Ref:- Planning Application 3/2023/0937

I write to express my concern with the proposed upgrade on the properties on the Kirkfield Estate and in particular the works highlighted in the planning application documents at number 9, the

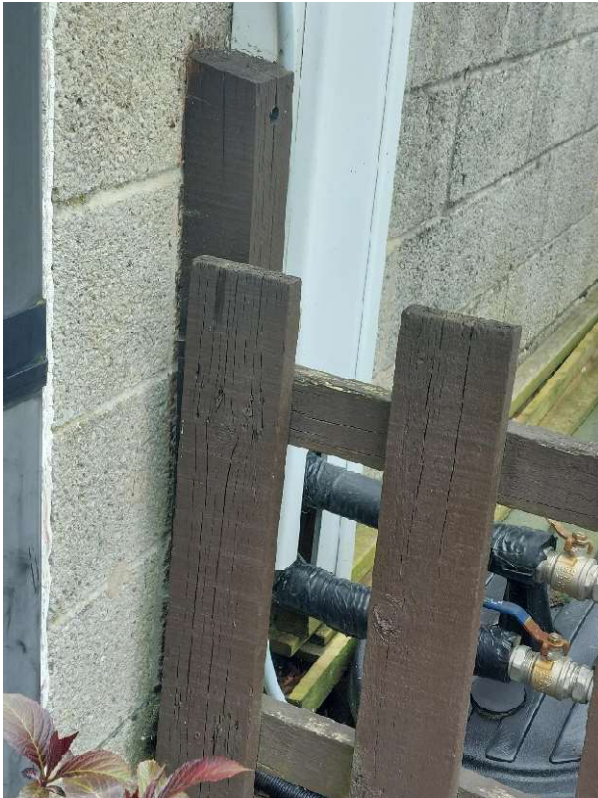
- 3. Backyard fence reduction in length to accommodate insulation to number 9's back wall.**
It is assumed the back yard timber fence will be reduced in length to accommodate the insulation and render; how will the contractor rectify this?
